Broadcast Products Technical Bulletin 20-2003-091

SUBJECT: **PICTURE DISTURBANCE AND GREEN PICTURE**

MODEL: **BKM-21D**

Figure 1

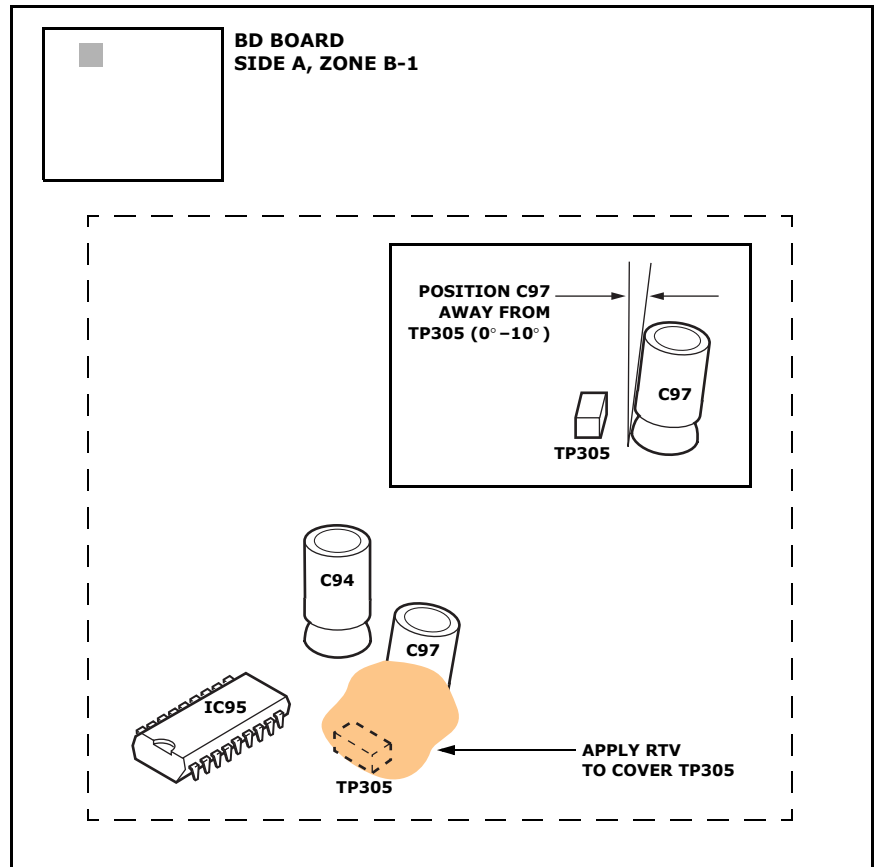
If C97 comes into contact with TP305, severe picture disturbance may occur and the picture may turn green.

BD Board (Side A, Zone B-1)

Remove TP305 if it is mounted,
or

Use RTV to hold C97 away from TP305 as follows:

1. Reposition C97 perpendicular to the board or approximately 10° away from TP305.
2. Apply RTV to C97 and TP305 as shown in Figure 1.
